MILLENIUM HX® WATER PURIFICATION SYSTEM PLC AND I/O MODULE CONNECTIONS

Figure 1. J4 and J5 Connection

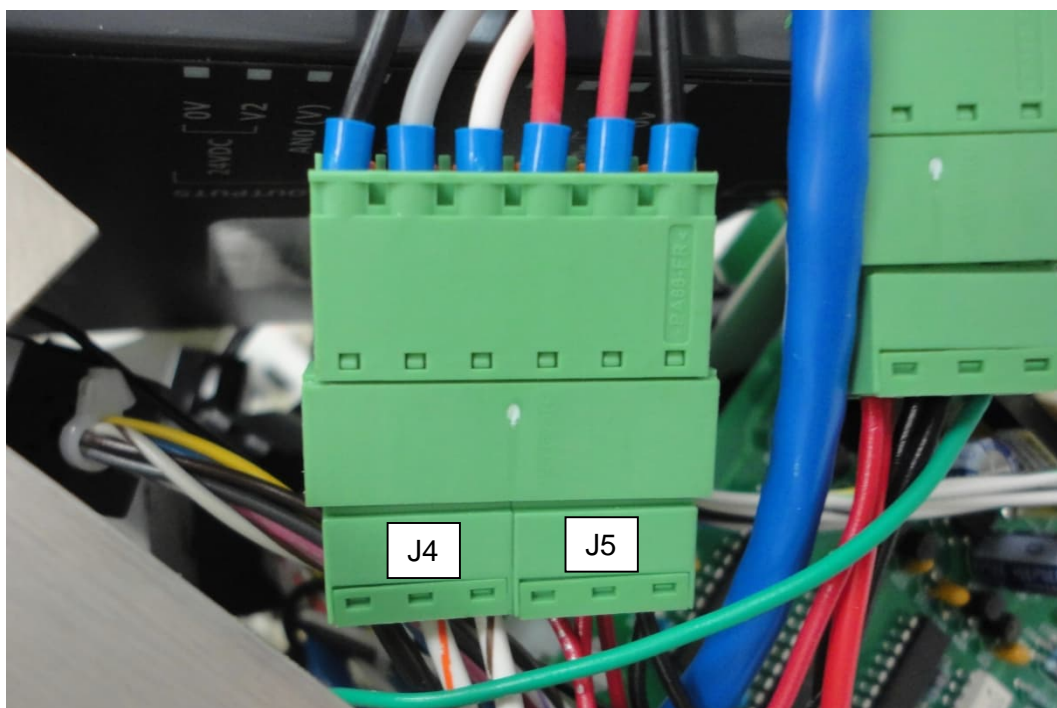
To mistake proof the power connections to the PLC and I/O module, connections J4 and J5 are being combined into a single connector. Replacement PLCs and I/O modules (replacement PN W3T577670) can still be used with existing machines without any wiring modifications by plugging both J4 and J5 into the new single connection (see Figure 1).
